Florida Fish and Wildlife Conservation Commission
RMI Reroof
St. Petersburg, Florida 33701

August 31, 2017

This forms a part of the contract documents and modifies the drawings and specifications dated May 17, 2017, as noted below.

RMI MARINE RESEARCH LABORATORY REROOF

CURB AT BUILDING DETAIL @ CONDUIT

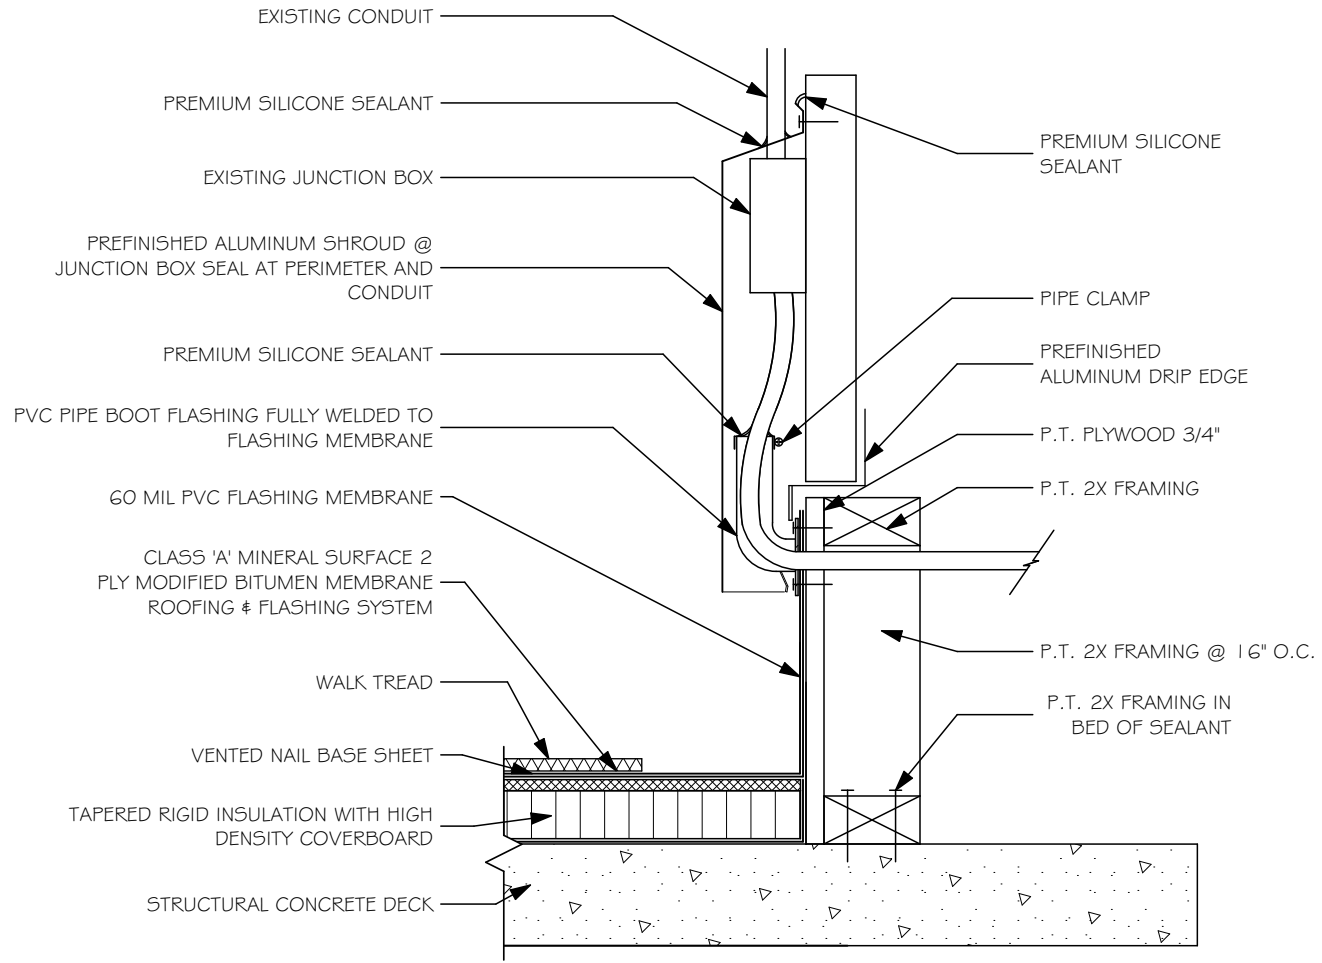
ITEM NO. 1: DRAWINGS, SHEET A001, RENOVATION NOTES AND A503, DETAILS:

- Add: Contractor shall coordinate with the building staff to determine if the conduit or waterlines around roof top buildings are still in operation.
- a. If electrical conduit/conductors are not in operation and are no longer needed, contractor to remove conduit and conductors in conflict with the roofing system/curb, as detailed, back to nearest junction box and terminate properly.

- b. If waterlines are no longer in operation and are no longer necessary, contractor to shut off the water at the nearest shut off valve and cap the water line under the roof deck, preferably in the ceiling of the floor below.

- c. If electrical conduit/conductors or waterlines are still in operation and are necessary to maintain, contractor shall install a new fully welded PVC boot flashing around each pipe penetration at new curb per manufacturers requirements. Then each conduit/pipe boot shall have a prefinished aluminum shroud installed around the boot to act as a modified counterflashing. New perimeter curb counterflashing shall be covered by the shroud and fully sealed at connection. Shroud shall be fastened to the building wall panels using stainless steel self tapping screws and sealed at the perimeter. See attached detail for additional clarification.
